INDESIT company

Model type:
LV65AIX

Commercial code:
F026623

n1045034: New top condenser.

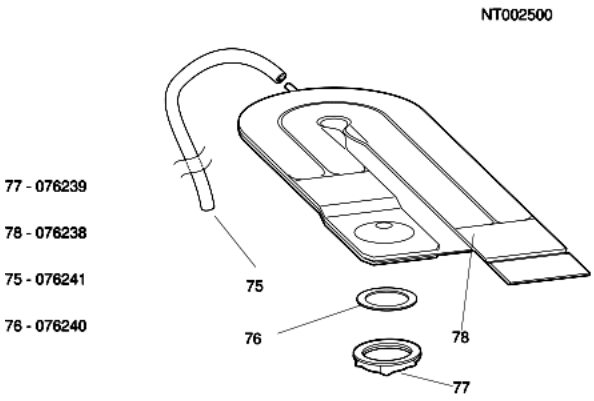
As of the last week in July 2000, the new "Wind drying system" was inserted on some appliances from the new MarckII Range. This new system foresees the elimination of the lateral air-flow body and the insertion of a new system with top condenser.
The spare part numbers eliminated are as follows:

054927(Rohs 144335) - RING NUT FOR AIR-FLOW BODY
054928 - AIR-FLOW BODY
103689 - NOZZLE GASKET
057874 - TOP SOUNDPROOFING LAYER

Whereas the new spare part numbers are:

076238 - WIND DRYNG SYSTEM CONDENSER
076239 - CONDENSER RING NUT
076240 - TOP CONDENSER GASKET
076241 - TOP CONDENSER PIPE

The new part numbers are not interchangeable with the old ones, as they are completely different. See technical drawing attached to notice NT002500.

Photo N1045062FIG1 illustrates the bottom of the dishwasher with EVO structure.

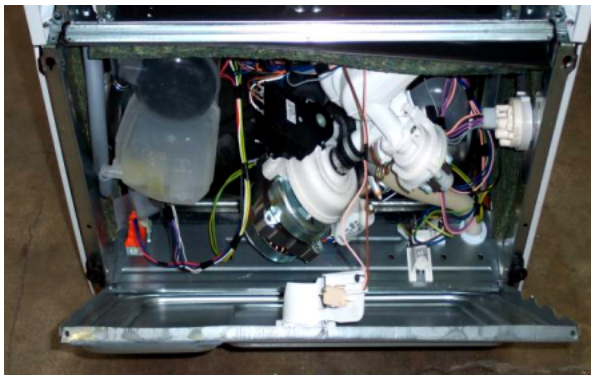
From serial number 30101.0001, all dishwasher models affected by this modification have been produced with EVO structure.
These models have been equipped with NEW TRAYS AND NEW FEET (see N1045062TAB1).

PREMODIFICATION:
Tray: 083625 (for commercial code 28490) 078809 (for commercial codes 26043-23520-28088);
Tray rear feet: 078396-078397-078385;
Tray front feet: 073972;
Front feet supports: 065836(Rohs 143584);
Feet supplied with plinth accessories assembly: 034261;

EVO STRUCTURE:
Tray: 092558 (for commercial code 28490) 092554 (for commercial code 26043-23520-28088);
Tray rear feet: 092820-092821-092822;
Tray front feet: 092555;
Front feet supports: 065836;
Feet supplied with plinth accessories assembly: 034261.

Regulation assembly DX/SX Sat codes 078397 and 078396 will be managed up to stock end, after that they will be replaced by new Sat codes 092821 and092820. The same is for rear foot Sat code 078385 which will be replaced by Sat code 092822.

N1045063

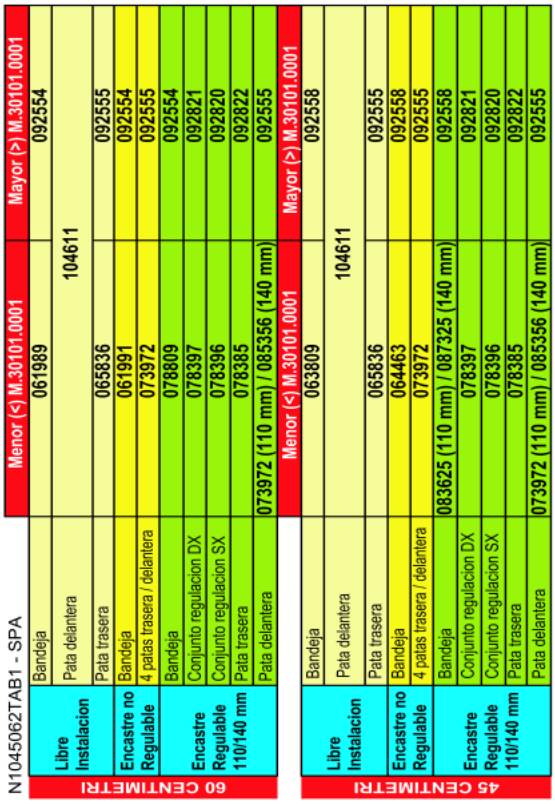
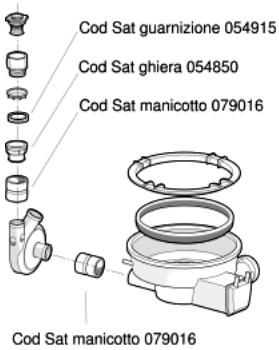
From serial number 30224.0001, all dishwashers affected by this modification have been equipped with the new coupling+ring nut assembly Sat code 093752, in place of coupling Sat code 079016, ring nut Sat code 054850 and gasket Sat code 054915.

Ring nut Sat code 054850 will continue to be available from the spare parts warehouse while stocks last, and coupling Sat code 079016 will continue to be stocked because it is still used for the tank-volute connection.
Picture N1045063 illustrates the premodification structure in FIG1 and the new structure in FIG2.

N1045081FIG1

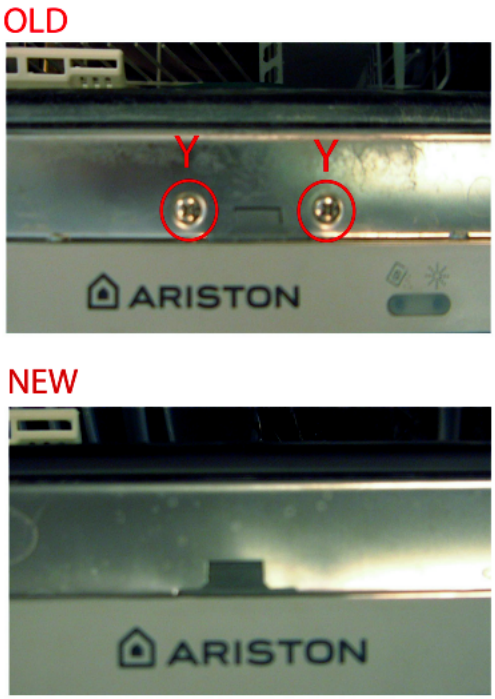
From serial no. 40614.0001, all 60 cm dishwashers affected by this note have been equipped with the locking unit code 094128 in place of 085357.
Following the elimination of the two screws Y (see N1045081FIG1) used to fix the locking unit on the inside door, the locking

unit and inside door were also modified, which can be mounted on premodification appliances by replacing the premodification locking unit with the new one.

Codes of modified inside doors:
085023 PREMODIFICATION - 112451 NEW
